PRODUCT SUPPORT BULLETIN

BULLETIN NO. 305

MACHINE: **Model C Spike Driver**
Model 99C Spike Driver

SUBJECT: **Two-piece Anvil Assembly**

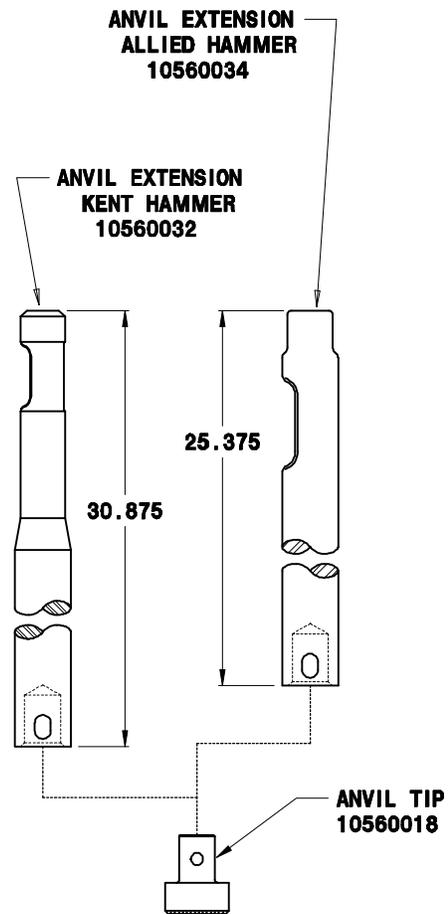
A new Two-piece Anvil Assembly has been designed to replace the original One-piece Anvil, part numbers 10560024 and 10560030, used on all Model C Spike Driver machines and 99C Spike Driver machines up to s/n410248. Model 99C machines s/n410249 and up are equipped with 2-piece anvils as standard equipment.

The Two-piece Anvil consists of an Anvil Extension and a replaceable **Anvil Tip, part number 10560018**. There are two different length extensions for the two different makes of hammers. Both hammers will use the same tip. The tip is attached to the extension with a **Spirol Pin, part number 53643950**.

Anvil Extension 10560034 is for machines equipped with Allied spike hammers. The Allied Anvil extension is 25.375" long. Allied hammers are mounted on the machine with 2 large pins.

Anvil Extension 10560032 is for machines equipped with Kent hammers. The Kent hammer Anvil Extension is 30.875" long. Kent hammers are mounted with 4 capscrews and nuts.

When the anvil wears out, only the tip needs to be replaced instead of the entire anvil. This will reduce cost as well as the time required to replace the anvil.

**BOTH ANVILS USE A ROLL PIN,
P/N 53643950 TO ATTACH THE
TIP TO THE EXTENSION**
